MEMORANDUM FOR: Darrell G. Eisenhut, Director of Licensing, NRR
FROM: Charles E. Norelius, Director, Division of Engineering and Technical Inspection, RIII
SUBJECT: PARAS 1 AND 2, AUXILIARY BUILDING SEISMIC ANALYSIS AND CRACKS IN THE BORATED WATER STORAGE TANK FOUNDATION

MIDLAND PROJECT
MIDLAND DOCKET NOS 50-329, 50-330
RESPONSE TO NRC STAFF REQUEST FOR ADDITIONAL INFORMATION PERTAINING
TO THE PROPOSED UNDERPINNING OF THE AUXILIARY BUILDING AND
FEEDWATER ISOLATION VALVE PITS
FILE 0485.16, B3.0.1 SERIAL 14869
REFERENCE: JWCOOK LETTER TO HRDENTON, SERIAL 14110, DATED 9/30/81
ENCLOSURE: RESPONSE TO THE NRC STAFF REQUEST FOR ADDITIONAL
INFORMATION PERTAINING TO THE PROPOSED UNDERPINNING
OF THE AUXILIARY BUILDING AND FEEDWATER ISOLATION VALVE PITS

RESPONSE TO THE NRC STAFF REQUEST
FOR ADDITIONAL INFORMATION PERTAINING TO
THE PROPOSED UNDERPINNING OF THE
AUXILIARY BUILDING AND
FEEDWATER ISOLATION VALVE PITS

RESPONSE TO NRC STAFF REQUEST FOR ADDITIONAL INFORMATION PERTAINING
TO THE PROPOSED UNDERPINNING OF THE SERVICE WATER PUMP STRUCTURE
FILE 0485.16, B3.0.8 SERIAL 14843

DETAIL OF TYPICAL FREEZE ELEMENT

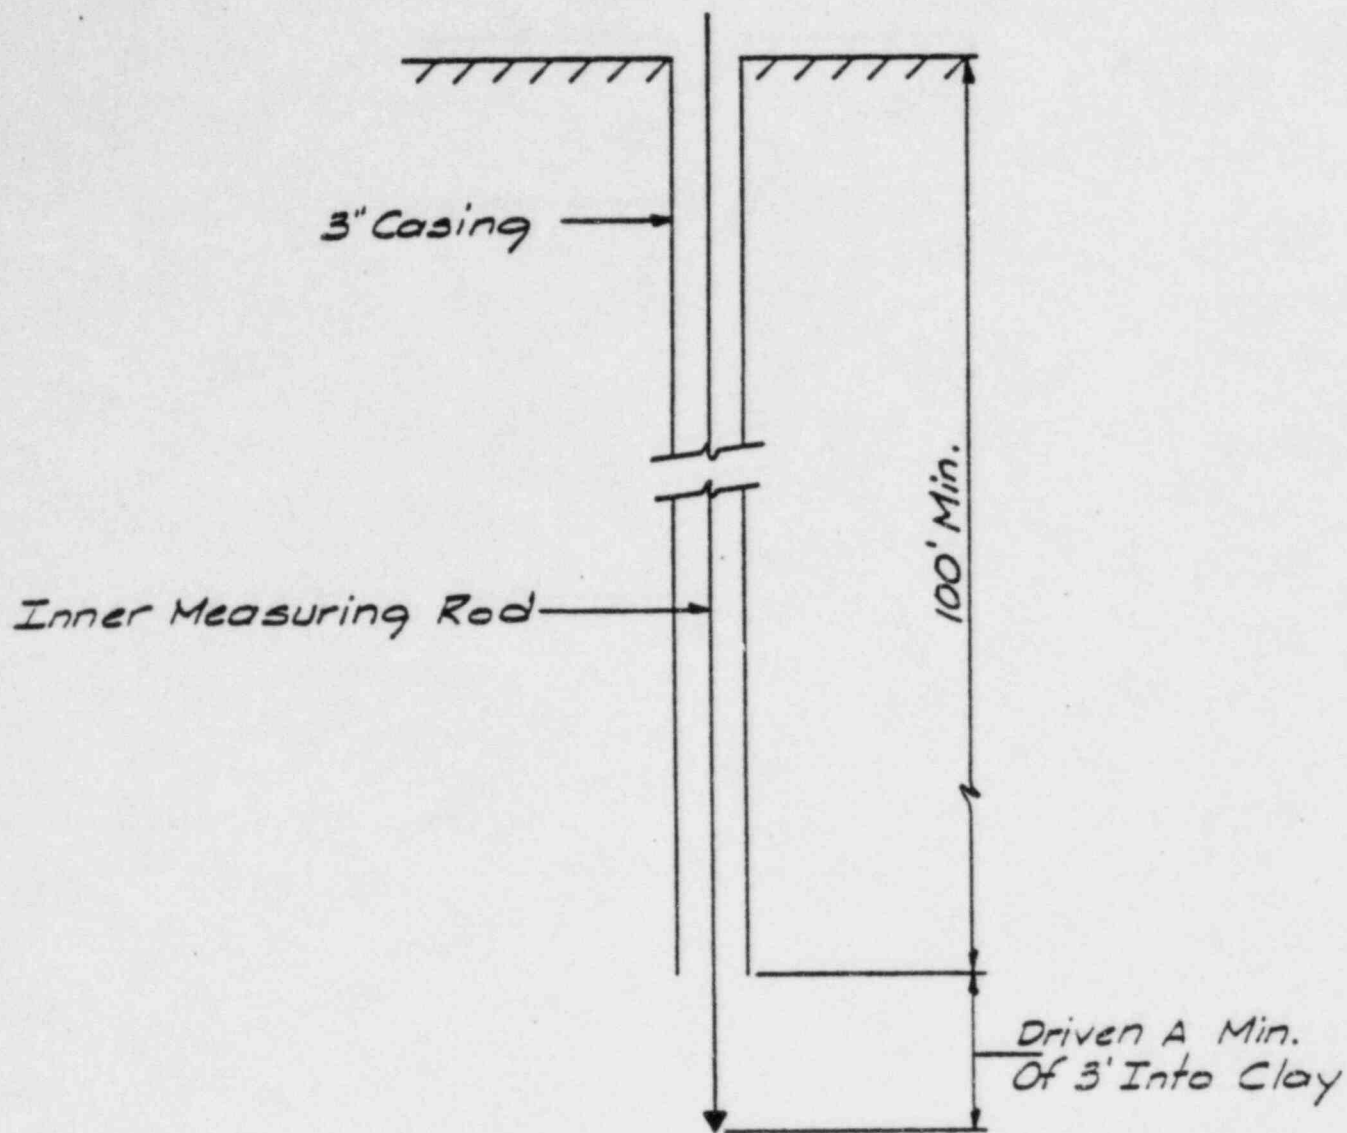
(Pg. 3, Sect. 5.1, Para. b) Installing the frozen cutoff membrane will cause expansion and possibly increase the soil voids. When ultimately unfrozen, what is the effect (e.g., further settlement) on safety-related structures, conduits and piping. Provide discussion on the basic system of the frozen membrane [size and spacing of holes to be drilled, method for pumping brine into foundation layers, range of temperatures that are critical to wall stability which are to be monitored, decommissioning (e.g., grouting, etc)].

The frozen earth membrane will be developed by installing 8-inch diameter pipes in the ground at approximately 4 feet, 3 inches on center, (see Figure 2). The coolant for the system will be 55 parts inhibited ethylene glycol to 45 parts water, instead of brine as previously indicated. During freezing, the coolant will have a temperature of approximately -20F. After the wall forms, the coolant will be maintained at -5F to 5F. The ground temperature at the edge of the frozen wall membrane (approximately 1 foot, 6 inches from the freeze pipe) will be 32F. These temperatures are less severe to the containment structures than the ambient temperature during winter.

DETAIL OF DEEP SEATED
BENCHMARK

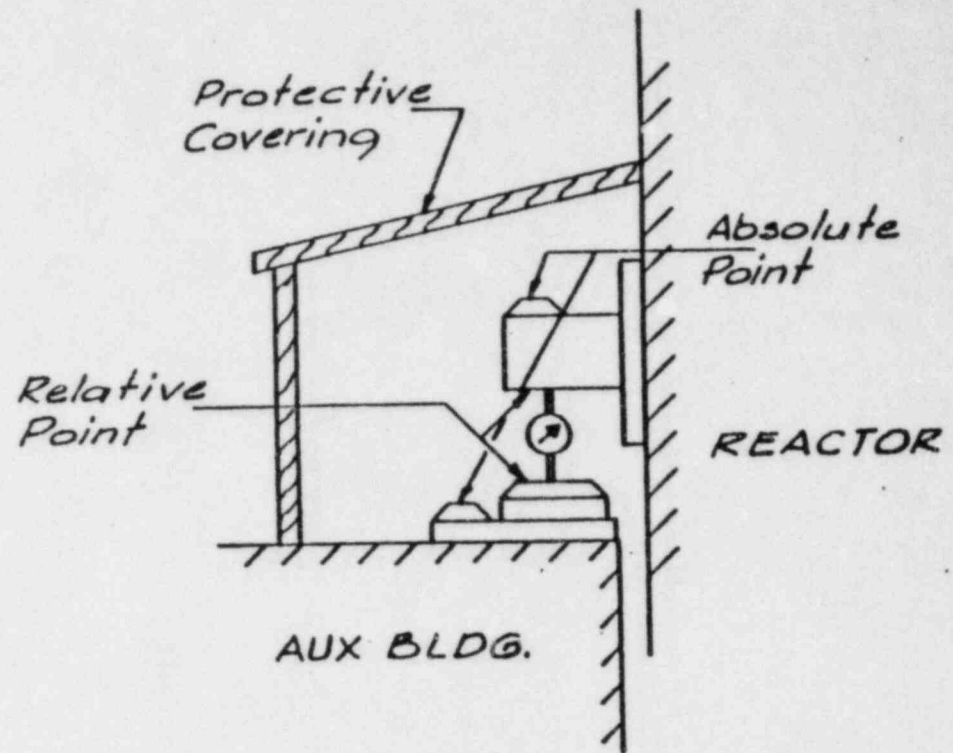
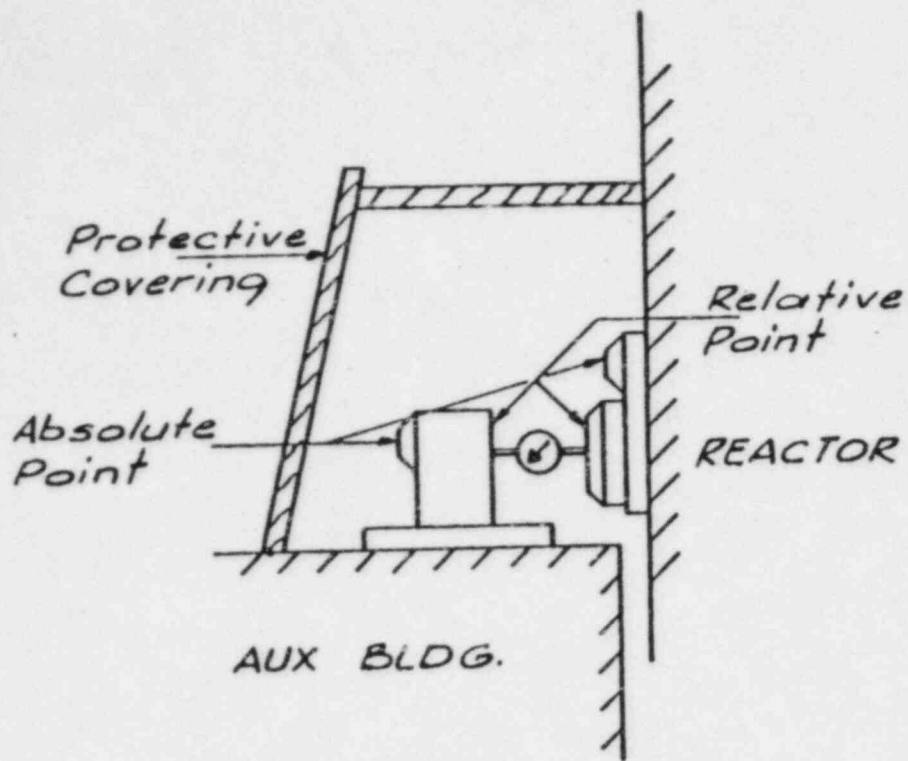
QUESTION 25

(Pg D-2, Sect. 1, 4th, 6th, and 7th Para.) Please provide elevations and sectional views with typical details for the deep

The absolute movement measuring system detects structure movements with respect to fixed datum points. The fixed datum points for vertical movement will be deep seated monuments. A detail for this is shown in Figures 4, 5, and 6.

DETAILS FOR MEASURING
RELATIVE MOVEMENTS

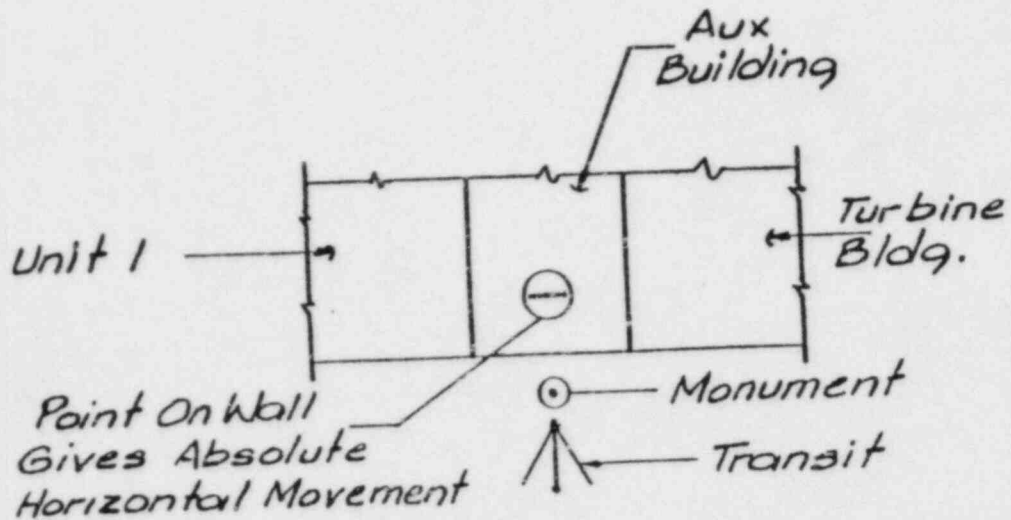
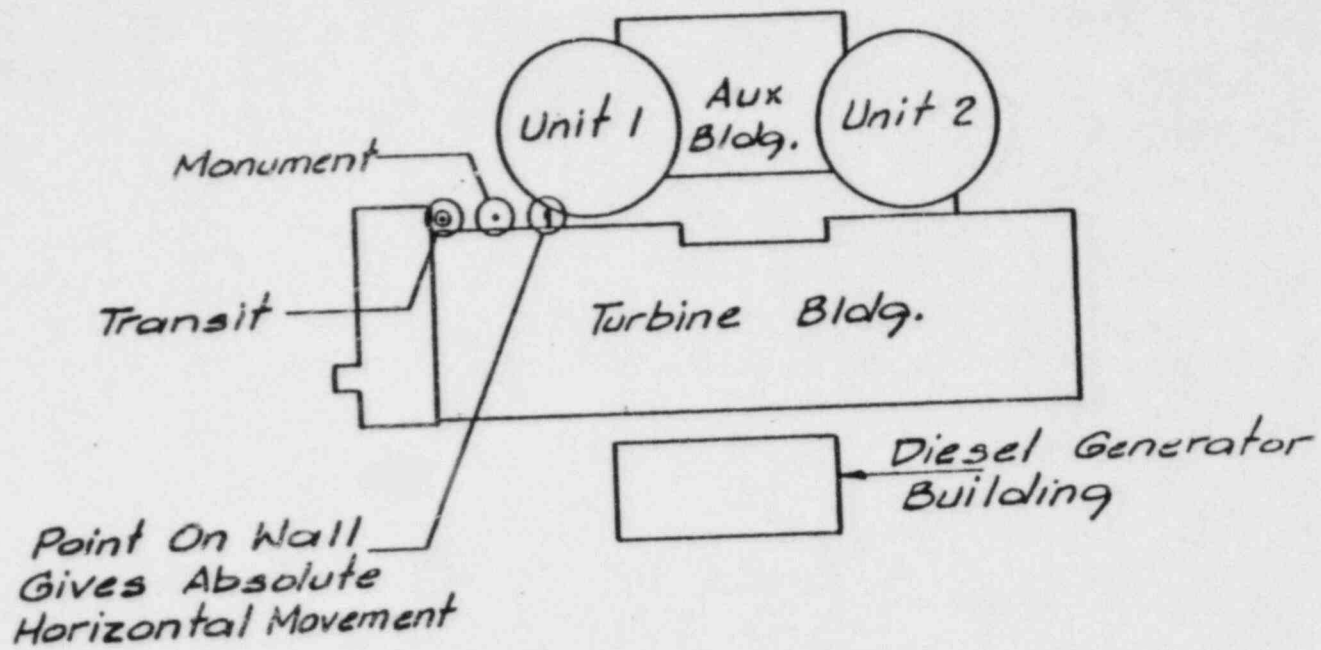
(Pg. D-3, Sect. 2, 3rd Par.) Provide sectional view of set up for measuring difference in relative position. How does this procedure address the possibility of both the underpinning element and structure settling? Provide the basis for maintaining the jack/hydraulic system for 1 hour and for establishing the 0.01 inch movement.

The detail for measuring differences in relative position is shown in Figure 5. The relative measuring devices gives warning that settlements are occurring. The absolute vertical movement of the structure will be measured and compared with the data from the instrumentation on the underpinning elements to indicate if both are settling.

CONSUMERS POWER COMPANY MIDLAND PLANT UNITS 1 & 2
JACKING LOADS UNDERPINNING AUXILIARY BUILDING PERMANENT UNDERPINNING
FIGURE 1

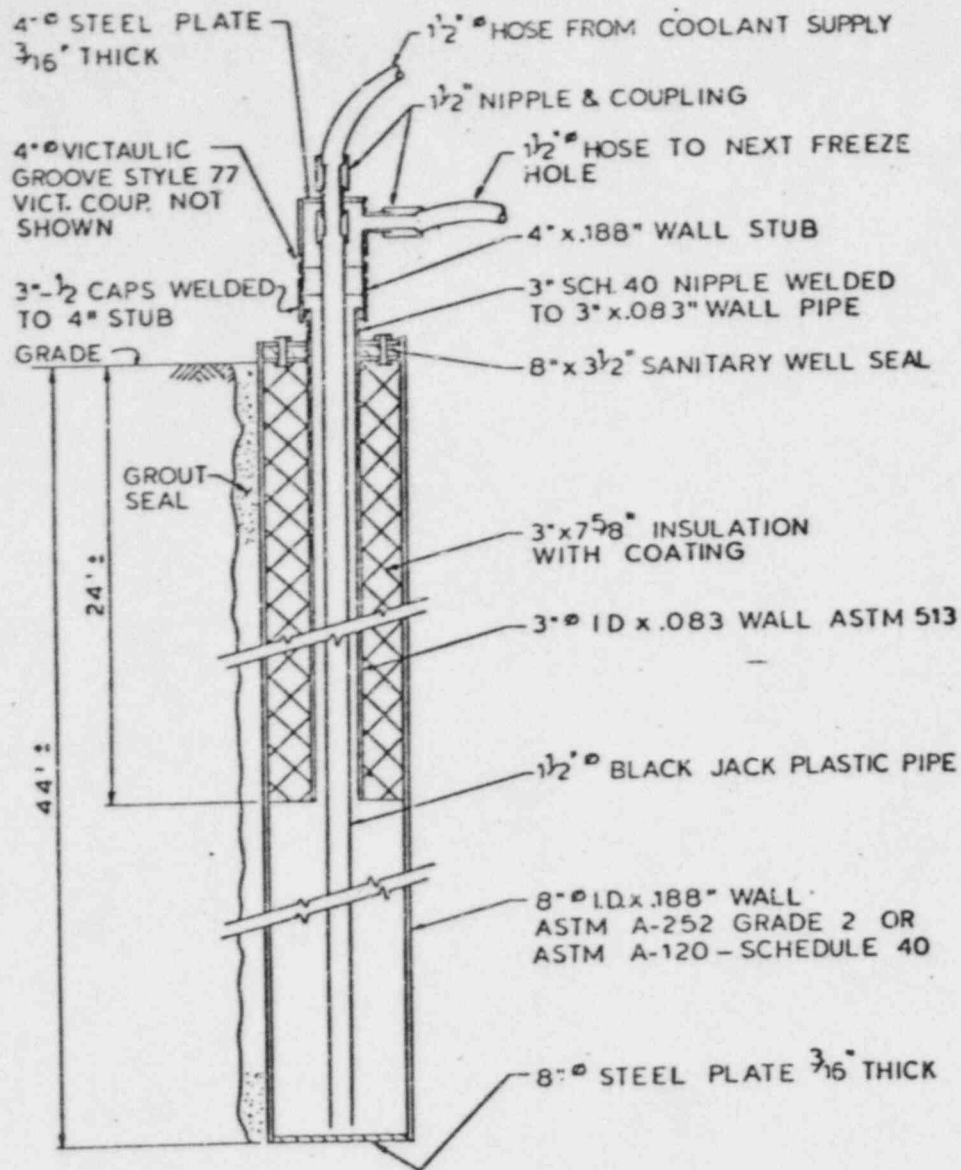
QUESTION 1

The design jacking force was based on an estimated reaction for dead load and 25 percent of the live load condition. The jacking load was calculated so that in each area the jacking force was approximately equal to the load from the structure above. The total jacking force in various areas is shown in Figure 4 of Reference 1. The average load per linear foot in various areas is shown in Figure 1. The adequacy of the jacking load will be verified by analysis.
